# EXPERT-PANEL REVIEW OF CNWRA VOLCANISM RESEARCH PROGRAMS

**Nuclear Regulatory Commission  
Contract NRC-02-93-005**

**Center for Nuclear Waste Regulatory Analyses  
San Antonio, Texas**

**January 1995  
Revised March 1995**

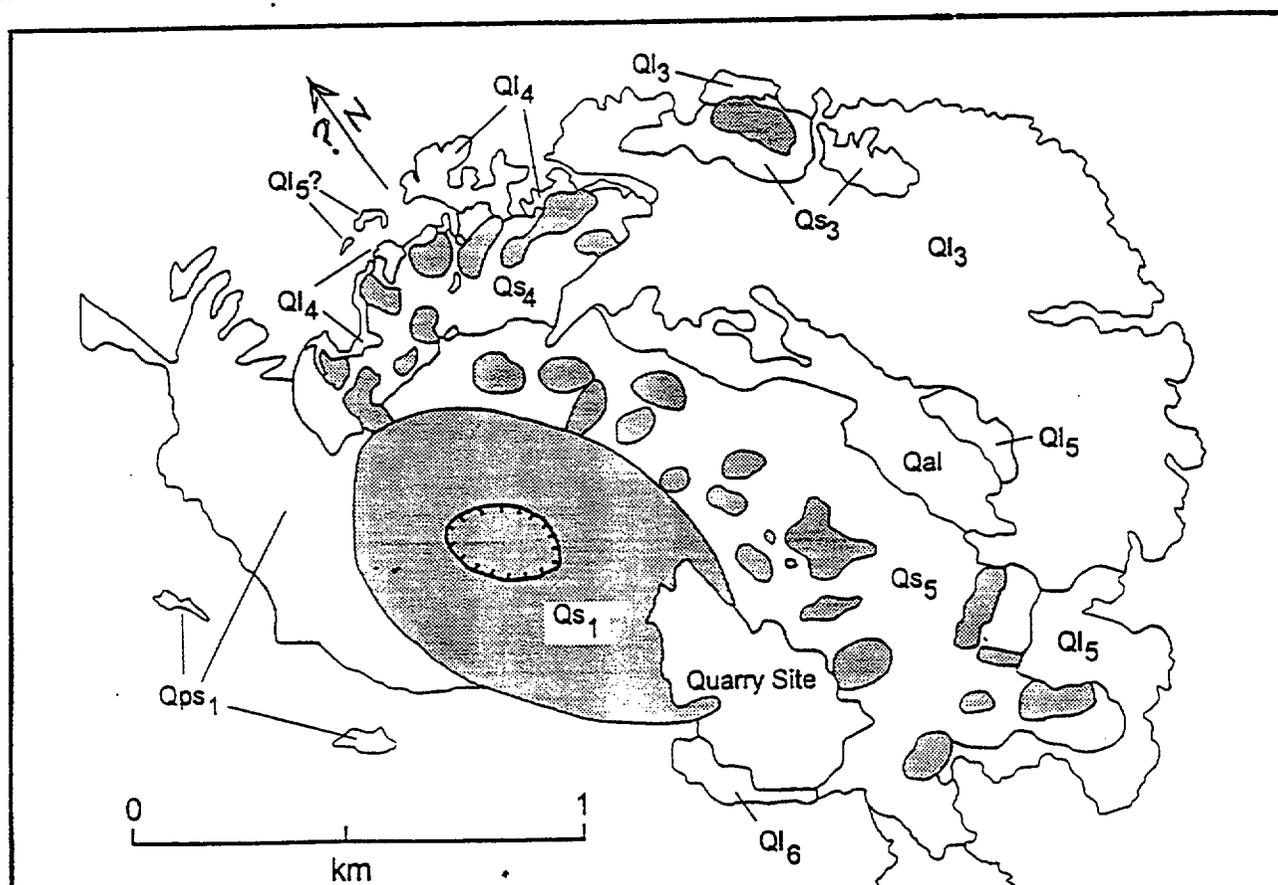
According to some published accounts, Lathrop Wells volcano is "polycyclic" (i.e. polygenetic: built by two or more eruptions). This conclusion appears to depend on the interpretation of scoria mounds found around the foot of the main cone as small cones situated at multiple primary vents. According to this interpretation, rough alignments of these mounds would reflect primary eruptive fissures, three of which (in addition to the fissure presumed to underlie the main cone) would then be required to account for all of the mounds. Also, cinder cone and lava flows have been interpreted to form during separate eruptions.

This published map of Lathrop Wells volcano shows numerous small stippled areas representing small scoria mounds outside of the main cone. I have seen an interpretation in which these mounds mark multiple vents developed on several fissures additional to the main vent. A much simpler interpretation is that the mounds are scoria rafts carried laterally on lava flows. I have watched such rafts forming. Ashy material at one of the small areas labelled Qps is interpreted as pyroclastic surge deposits. I was unimpressed by this interpretation.

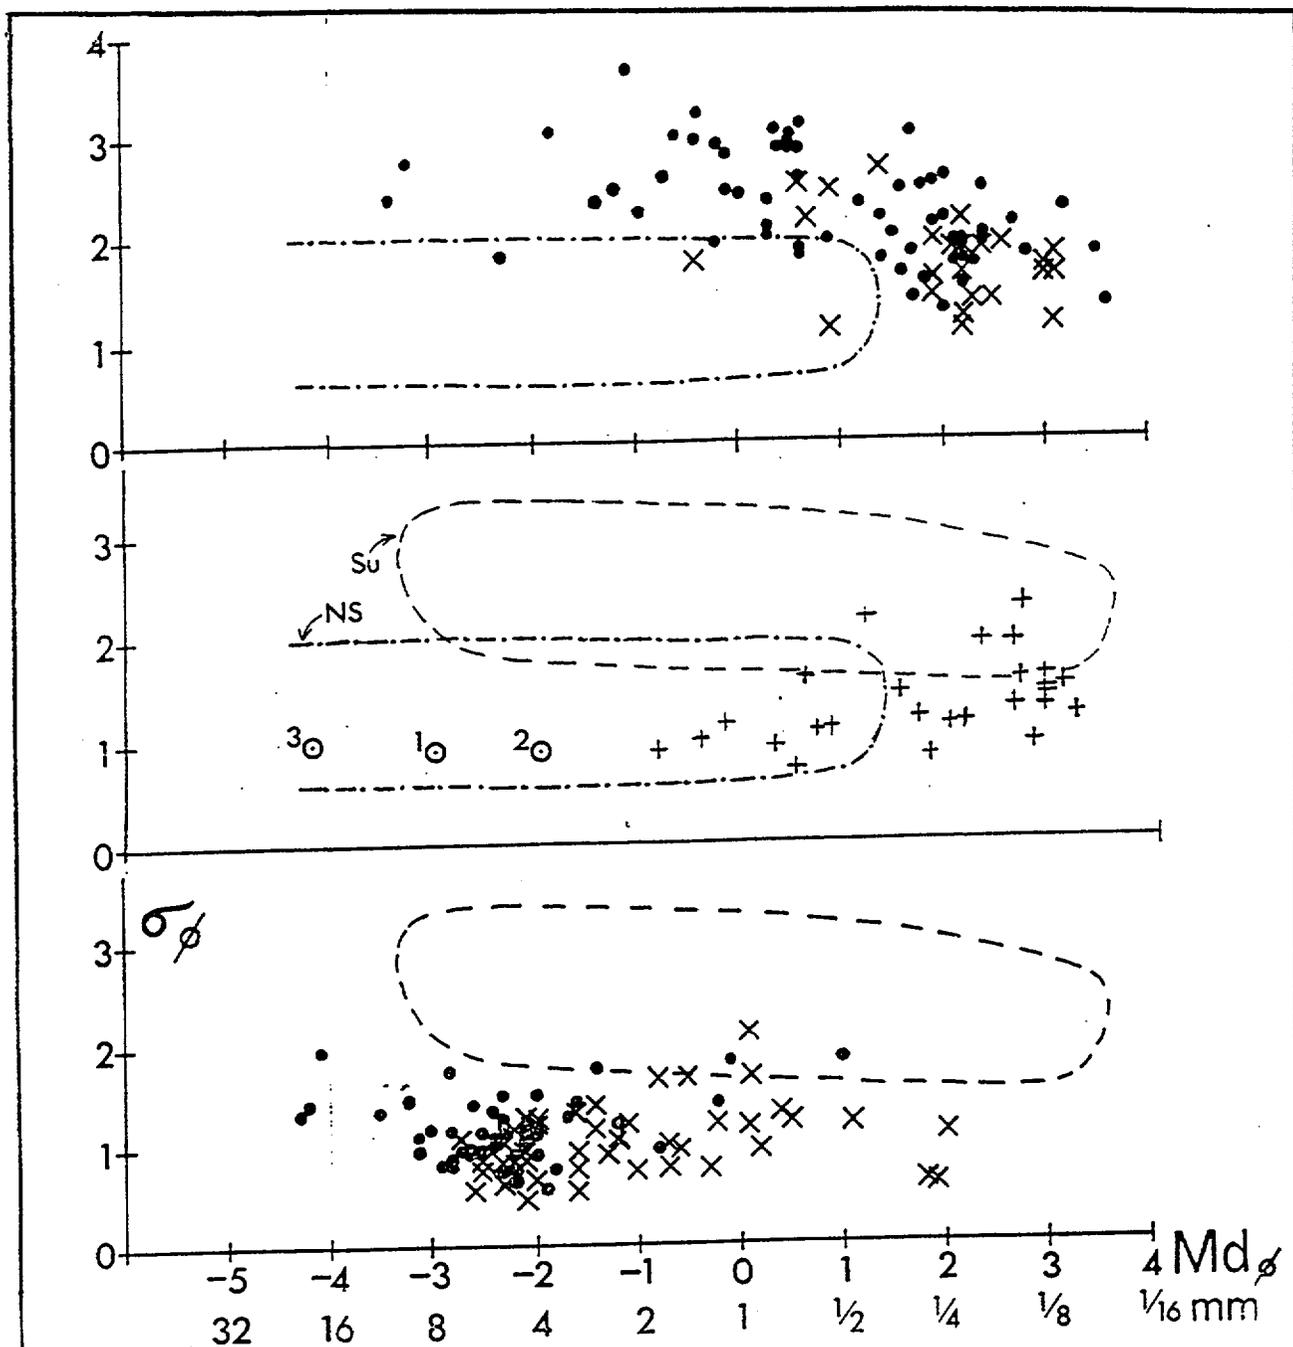
- #1 Pit just off foot of cone, Walthrop Wells Volcano
- #2 Roadcut exposing scoria fall on lava flow, about 400 m south of cinder cone of Lathrop Wells Volcano
- #3 Pit on western side of Little Cone volcano.

sample	median diameter (phi)	graphic standard deviation (phi)
#1	-3.0	0.9
#2	-2.0	0.9
#3	-4.2	1.0

(note: the fine "tail" of sample #3 consists partly of sand blown into the scoria deposit).

Plots of Inman parameters graphic standard deviation ( $\sigma_\phi$ ) against median grain diameter ( $Md_\phi$ ), for surtseyan ashes (above) and normal-strombolian scoria-fall deposits (below), after Walker & Croasdale 1972 (Bull. Volcanol., 35: 303-317). Dashed line outlines field of surtseyan ashes (Su), and dot-dashed line the field of normal-strombolian (NS). Dots represent samples collected from the cone, and crosses represent samples of blanket deposits outside the cone.
